CITY OF CAMBRIDGE Community Development Department

Date: January 11, 2013

Re: MIT Kendall Square Zoning Petition – CDD Comments

Map prepared by Brendan Monroe on June 26, 2012. CDD GIS C:\Projects\KendallCentralStudy\K2ZoneHeightsProposedPUDs8x11.mxd

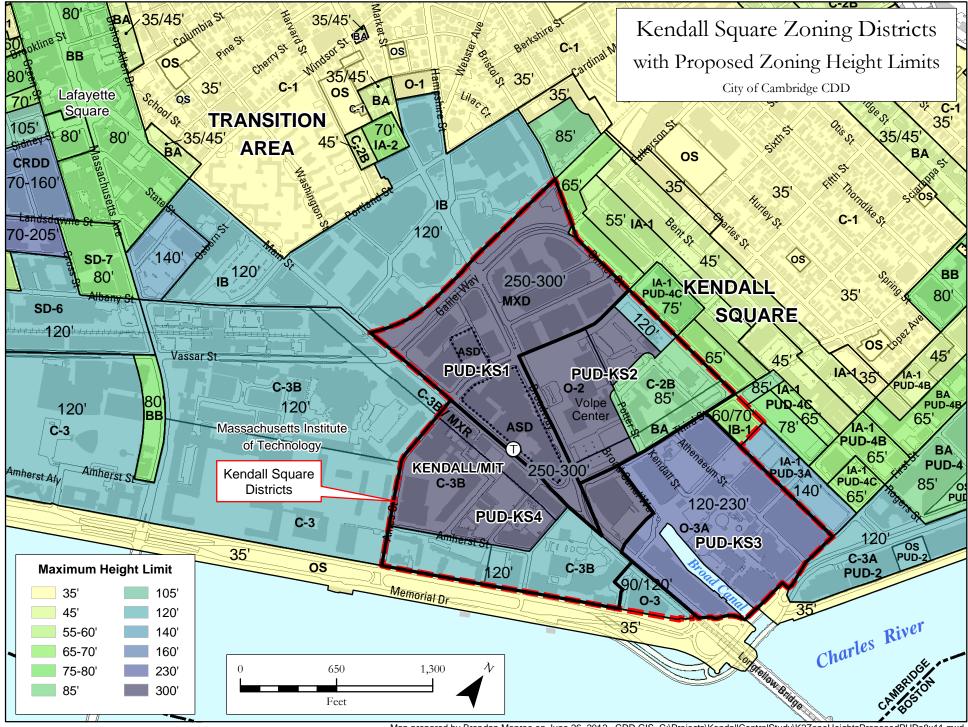
Zoning Petition Text (as Filed)	CDD Notes / Comparison to K2 Recommendations
13.81.1 <i>Establishment and Scope of Subdistricts within the PUD-5 District.</i> The PUD-5 District shall be divided into a series of Subdistricts as described below for the purpose of defining requirements that may not apply to the District as a whole. All provisions of the PUD-5 shall apply equally to each Subdistrict, except as provided for elsewhere in Section 13.80.	The height subdistricts recommended in K2 are somewhat different than those described below (refer to map), but they are conceptually similar by allowing greater height zones on Main Street near the T station and lower heights along the river. SEE ATTACHED MAP OF K2 HEIGHT RECOMMENDATIONS.

13.86 <i>Height</i>.13.86.1 In the Third Street Transition and the Main Street Subdistricts, the maximum height of any building shall be 250 feet, except as permitted by Sections 13.86.1.1 and 13.86.1.2.	The 250' height limit in the core of Kendall Square, and the allowance of 300' for residential uses, is consistent with the K2 recommendations. <i>SEE ATTACHED K2 HEIGHT LIMITS MAP.</i>
